PLAN REVIEW SHEET

Date:	12/14/07	Staff Contact:	David McDonald
Petitioner:	Centex Homes	Telephone:	704-336-6900
Petition:	2008-022	Fax:	704-432-1277
		Email:	dmcDonald@ci.charlotte.nc.us
Location:	Approx. 31.02 acres on northwest corner Tyvola Centre Dr. and W Tyvola Rd.	Attachments:	Shelter_Concrete_Standards.pdf (See 60.03A)
Existing Zoning:	BP(CD)		
Requested Zoning:	MX-2		
	To accommodate development of Residential community containing maximum of 248 for-sale Single-family attached town home dwelling units.

FIRST SUBMITTAL

STD. NO.	REV.
60.03A

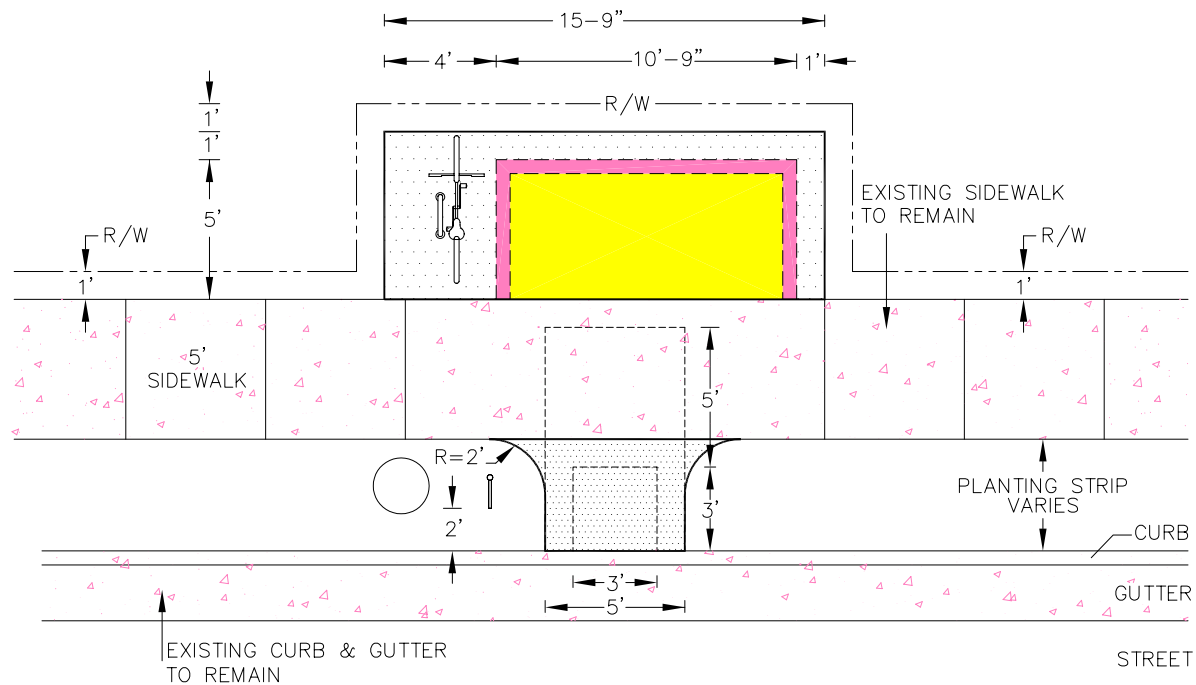
- 1) The petitioner's site is currently served on W. Tyvola Rd. by Route 16: South Tryon and Route 60 Tyvola/Southpark.
- 2) CATS requests sidewalk and a shelter pad to be constructed on W. Tyvola Rd. The shelter pad should be located approximately 60' north of the intersection of Tyvola Centre Dr. and W. Tyvola Rd. constructed to CATS Development Standards 60.03 A (see attached).

Please designate such in the site plan and/or accompanying notes. Please contact Leonard Ganther (CATS Operations) @ 704.432.1283 prior to demolition or construction, to coordinate the final location of the shelter pad.
